NEW! CERTAIN 2004 THROUGH 2006 MODEL YEAR F-150 AND 2006 MODEL YEAR MARK LT VEHICLES — CLOCKSPrING TO DRIVER SIDE FRONTAL AIR BAG WIRE HARNESS REPLACEMENT

OVERVIEW

FIGURE 1

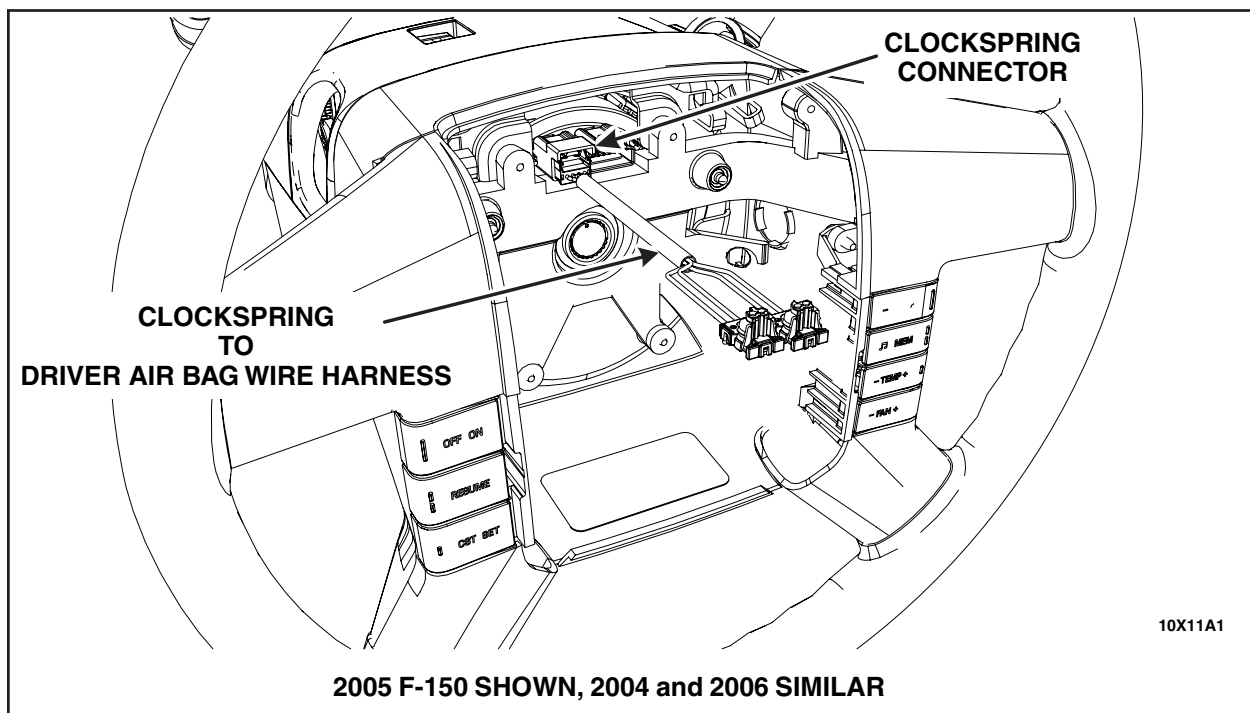
On some of the affected vehicles, it may be possible for the clockspring to driver side frontal air bag wire harness to chafe on the horn mounting plate. This may cause the air bag warning lamp to illuminate in the cluster indicating service is required. If the air bag warning lamp is ignored, this chafing may cause the driver side frontal air bag to inadvertently deploy and may result in personal injury. Dealers are to replace the clockspring to driver side frontal air bag wire harness with a service part that incorporates additional chafe protection.

1. Remove the driver air bag. For additional information, refer to the appropriate WSM, Section 501-20B.
2. Release the clockspring connector lock and disconnect the harness from the clockspring. See Figure 1.

3. Install the **new** clockspring to driver air bag wire harness using the following sequence:
 1. Connect the harness to the clockspring.
 2. Make sure the harness lock at the clockspring is seated.
 3. Connect the harness to the air bag.
4. Install the driver air bag. For additional information, refer to the appropriate WSM, Section 501-20B.
